10731854 Canada Inc.  
555 Legget Drive, Tower A, Suite 304  
Ottawa, Ontario, K2K 2X3

October 27<sup>th</sup>, 2020

RE: Combined Environmental Impact Statement (EIS) and Tree Conservation Report (TCR) (Revised)  
788 March Road, Ottawa, Ontario – Addendum #1

## SITE PLAN

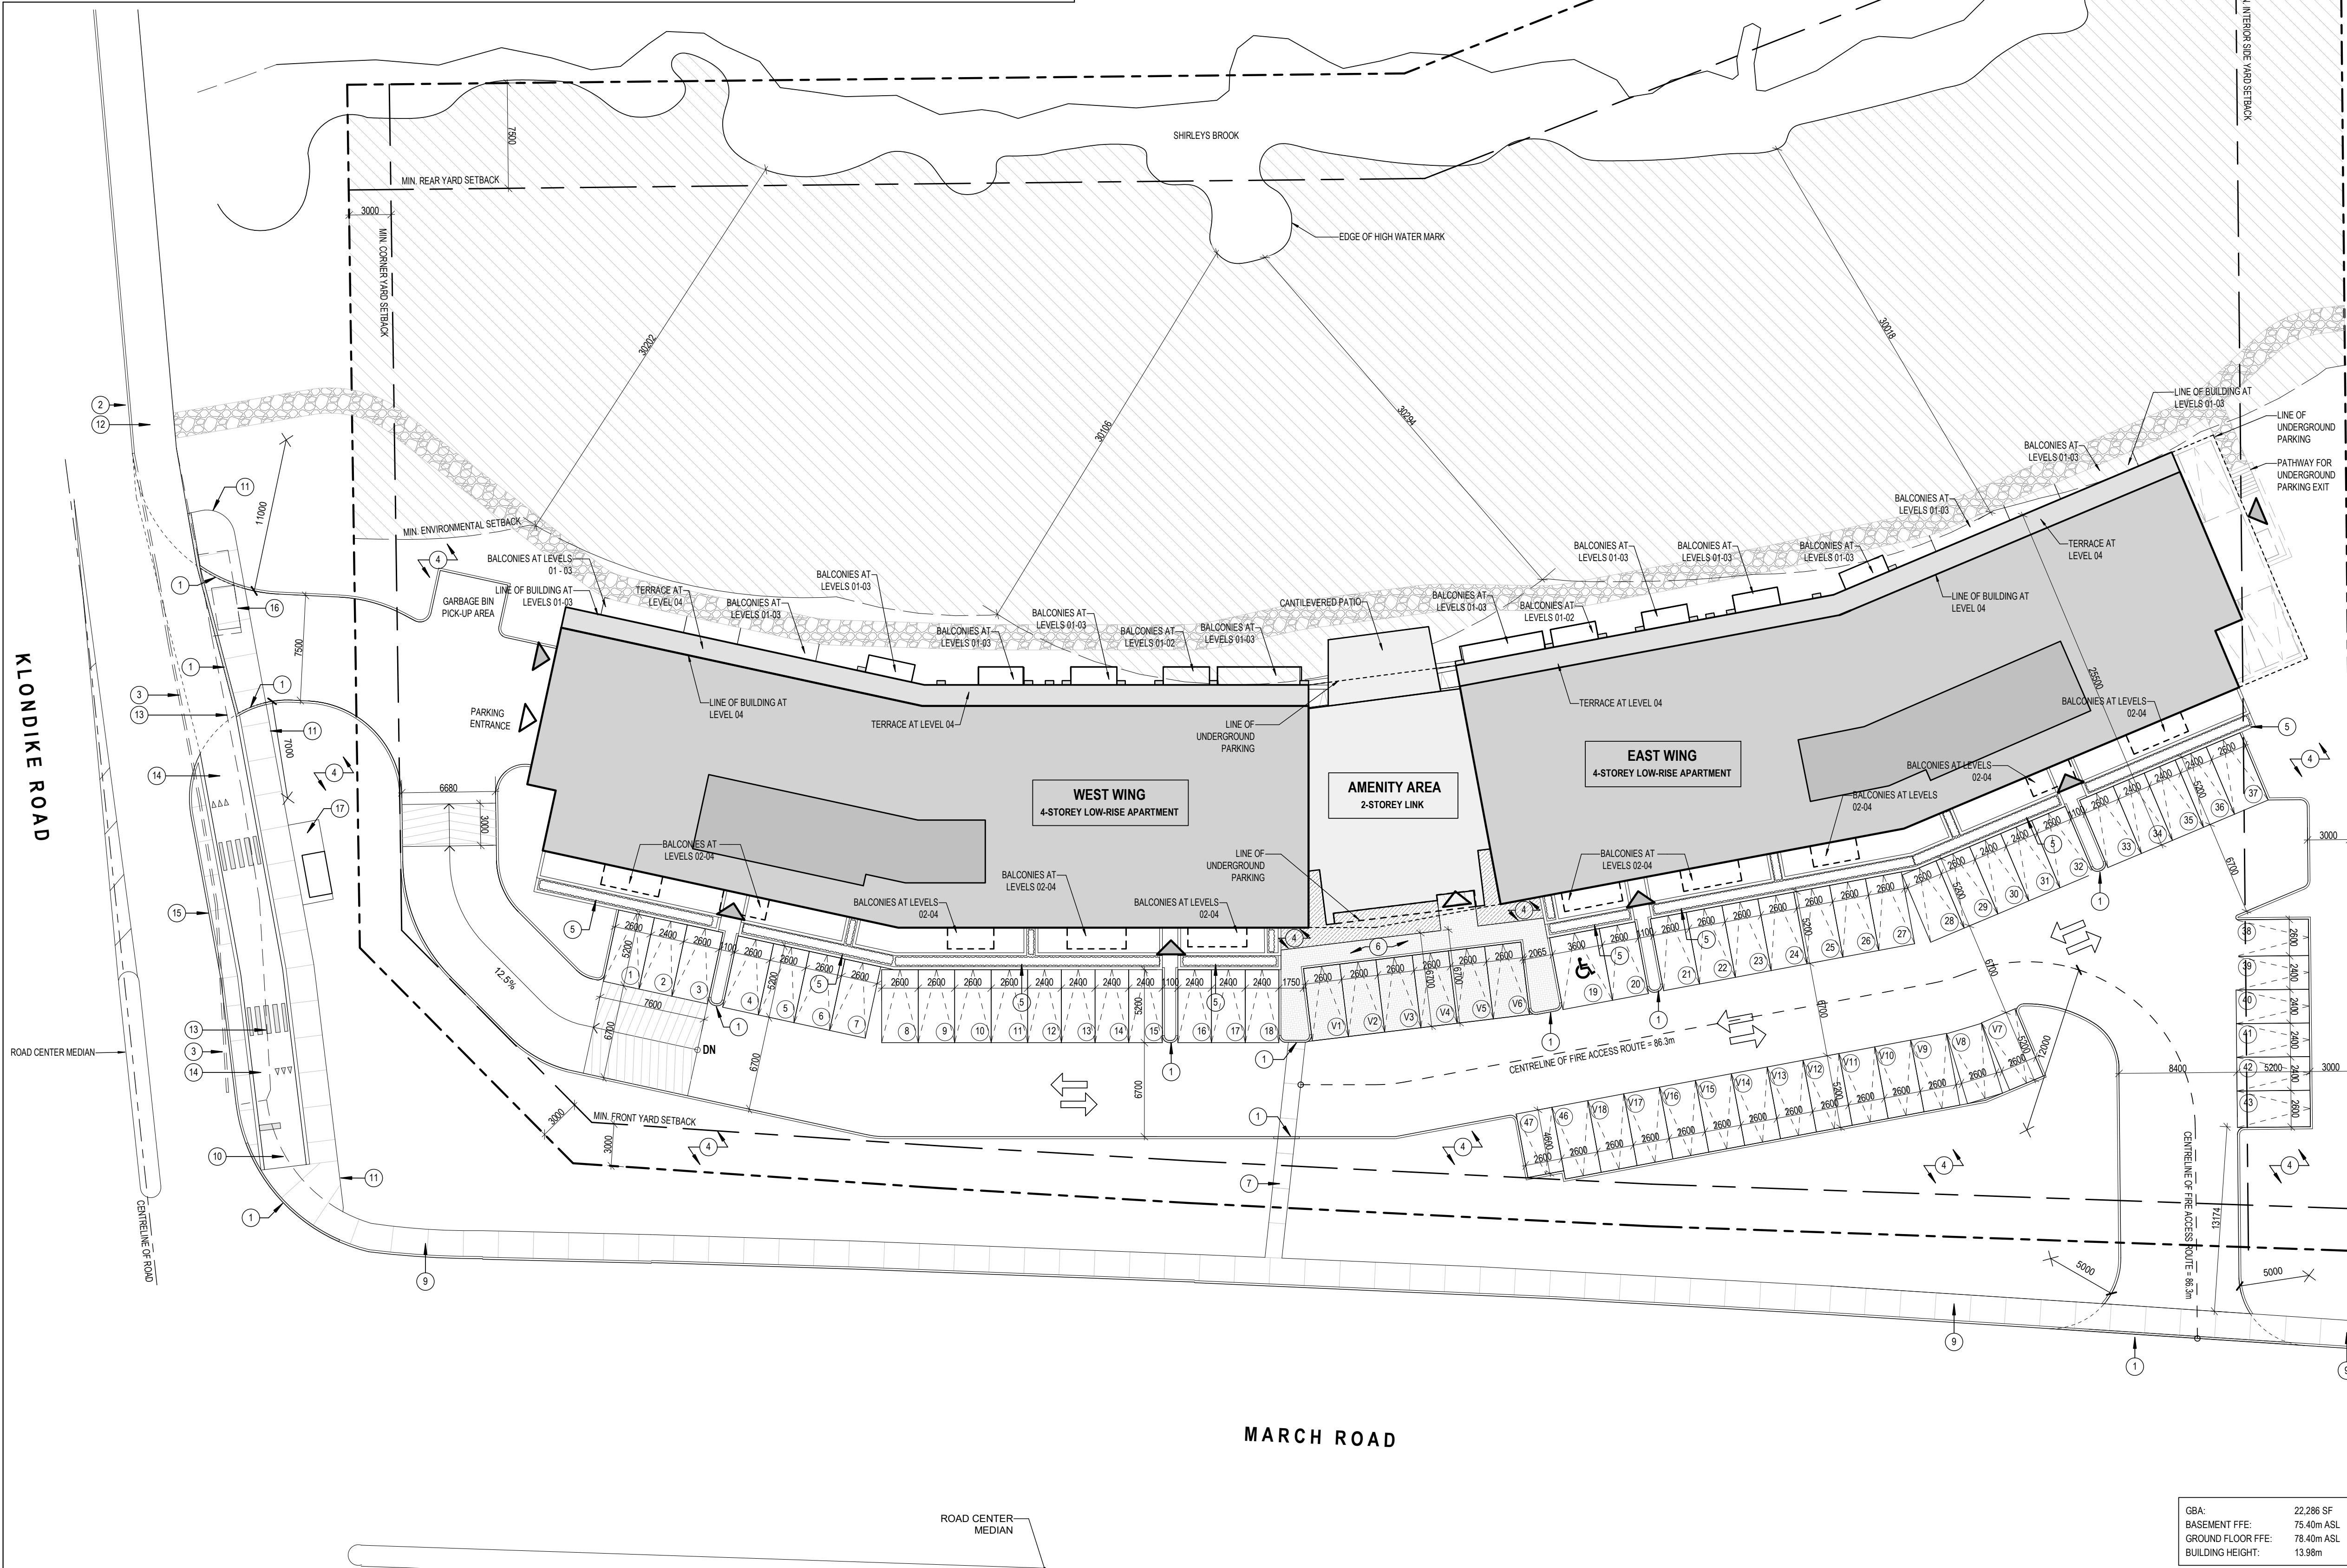
The updated Site Plan (SP-1) is included below. As it pertains to the natural heritage features found within and/or adjacent to the Site, the updated Site Plan does not differ significantly from the Site Plan that was included and discussed in MES (2020). The updated Site Plan (SP-1) does not significantly change the impact assessment, proposed mitigations measures, and/or recommendations previously described in MES (2020).
